**UNITED STATES ENVIRONMENTAL PROTECTION AGENCY
REGION II**

SUBJECT: U.S. Generating Company - Athens Generating Project
Approval of Meteorological Monitoring Site

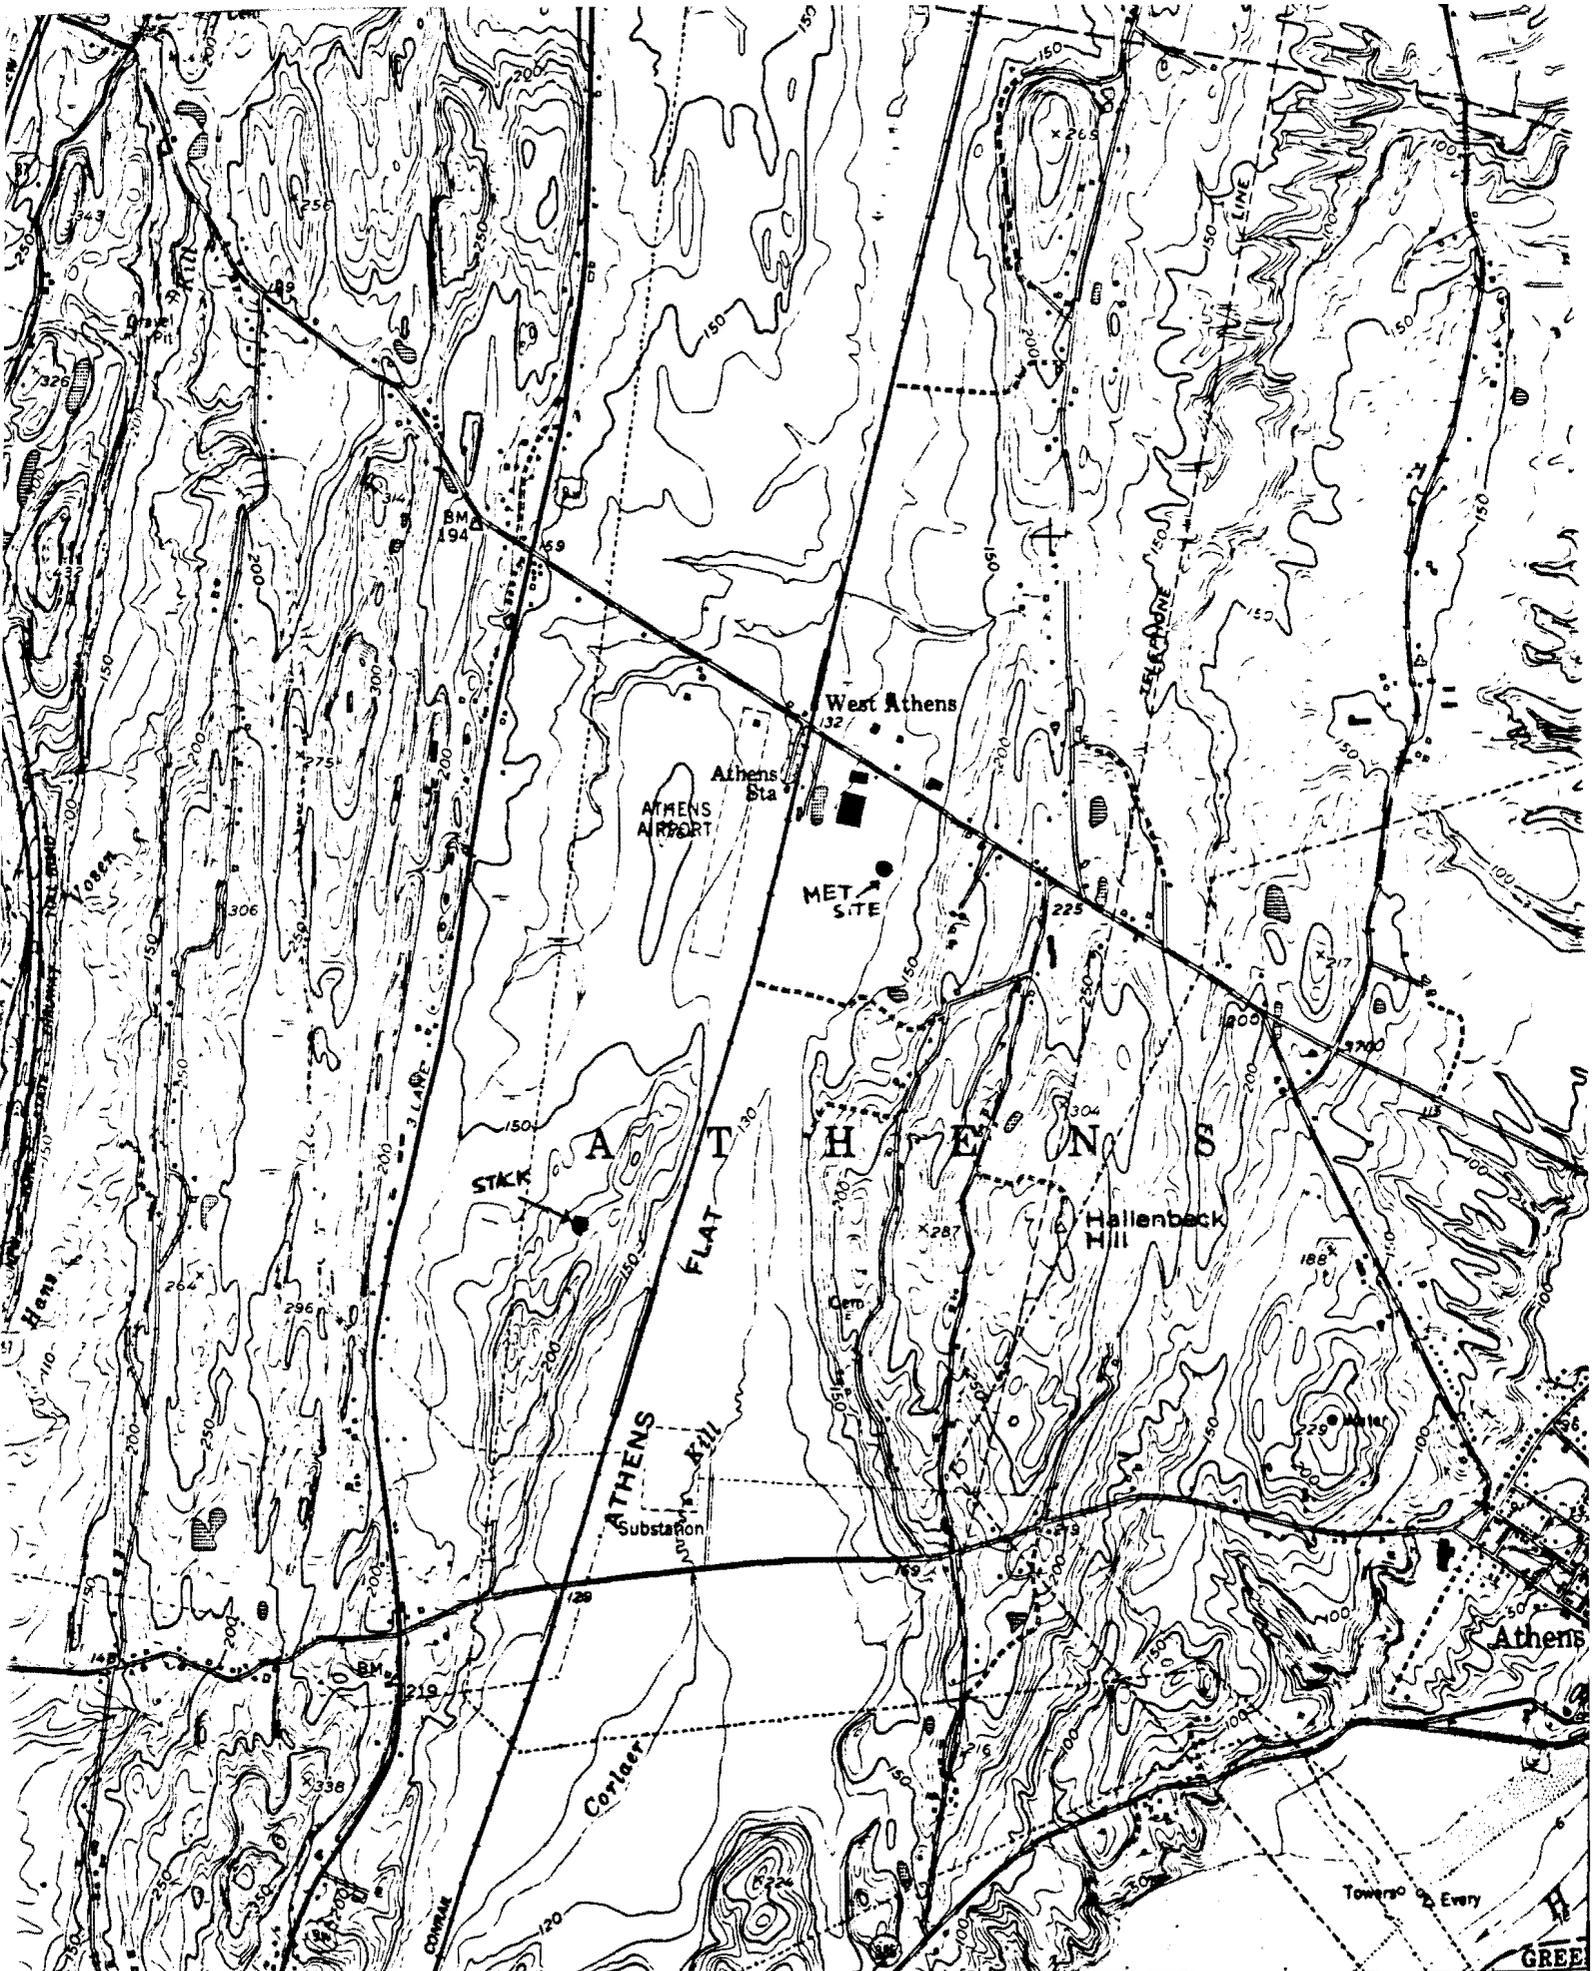
Region 2 recommends approval of the alternate site for the meteorological monitoring. The source location and the monitoring sites are located in the same topographical trough. The important physical characteristics (i.e., proximity to, slope and orientation of terrain) of the two locations are sufficiently similar that meteorological data collected from the two sites for use in dispersion modeling could be regarded as equivalent (On-site Guidance, Section 6.6). Both sites are aligned with long ridges to the east and west with a small hill abutted directly to the south. The proposed source and proposed monitoring site should experience equivalent atmospheric dispersive conditions given that there is similar terrain configuration, no interruption in terrain between the source location and the proposed meteorological tower site, and the separation distance is only 1.4 kilometers.

Although the base elevation of the stack is about 50 feet higher than the base elevation of the meteorological tower, this is not considered significant as the top of the tower will exceed the stack top. Another minor consideration is that the meteorological monitoring site is slightly closer to the eastern ridge while the proposed source location is in the middle of the trough. We believe these differences are not critical to the estimation of impacts from the models.
